*Waterville Valley Resort LLC
1 Ski Area Road
Waterville Valley, NH 03215
03/30/12 USEPA Inspection*

*Mobile Refueler/Snow Cat
300-Gallon Oil Tank Onboard*

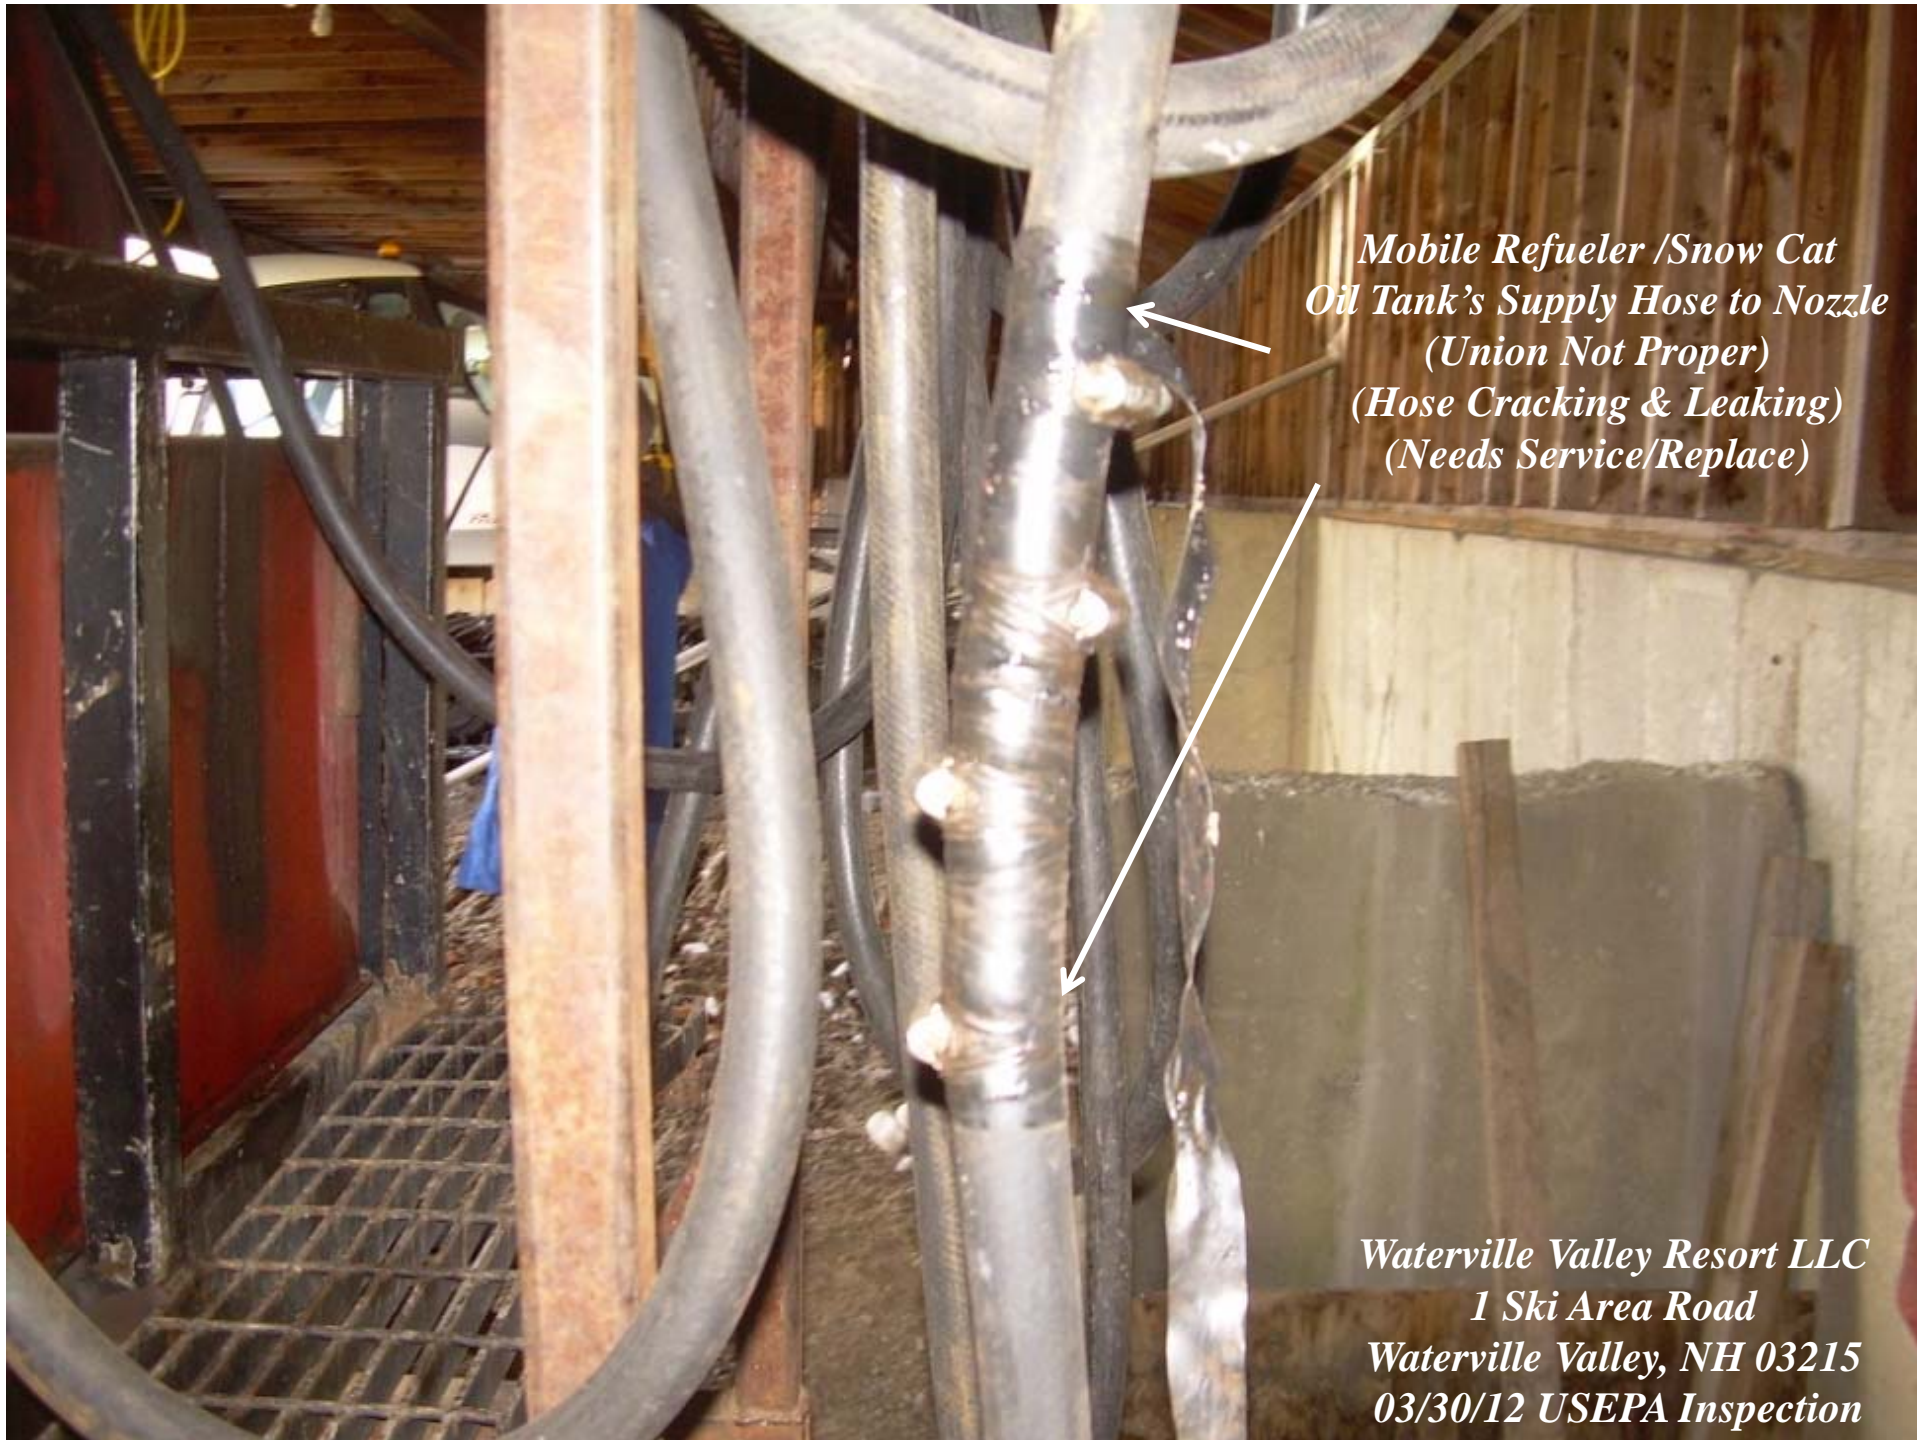
*Water w/Oil Leak from Oil Tank's Secondary Containment Area
(Inspect and Document Liquid for Oil Sheen Prior to Discharge)*

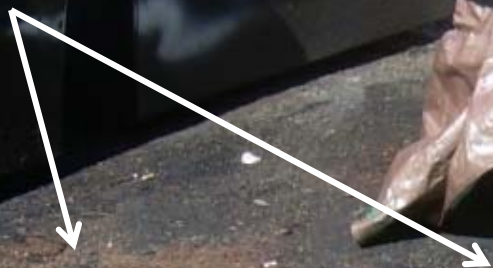
*Food Oil Waste Containers
(No Secondary Containment)
(Oil Spillage on Ground)
(Clean)*
